## 1 Products affected

Product Change Notification					PCN USF 0603 0.5 to 0.75 A and 1.5 to 5.0 A		
owner	creation date	release date	released by	change order no	rev	page	D10-013-693
ganderka	2017-02-07	2017-02-15	nowakfr	2012183	A	1 of 2

Old product appearance (example)	New product appearance (example)

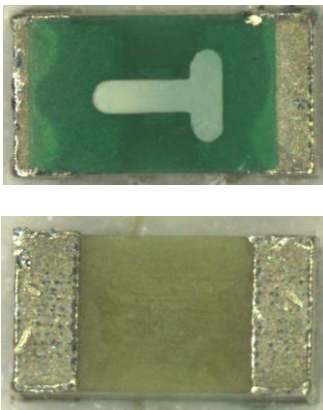
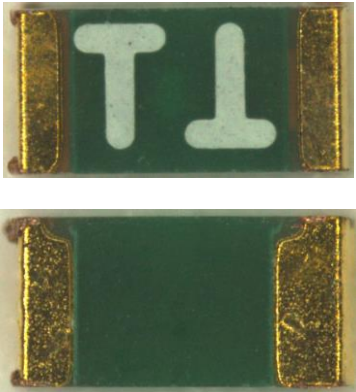
- Change of body material
- Change of nominal product height
- Change of terminal plating
- Modified blister tape
- Modified reel diameter
- Improved markings

Old terminal plating	New terminal plating
Ni/Sn	Ni/Au
Old nominal product height	New nominal product height
0.6 mm	0.7 mm
Old blister tape	New blister tape
Pocket height: 0.65 to 0.75 mm	Pocket height: 0.7 to 1.0 mm
Old reel diameter	New nominal product height
For packing unit 5'000 pcs. (xxxx.xxxx.24): 180 mm	For packing unit 5'000 pcs. (xxxx.xxxx.24): 254 mm
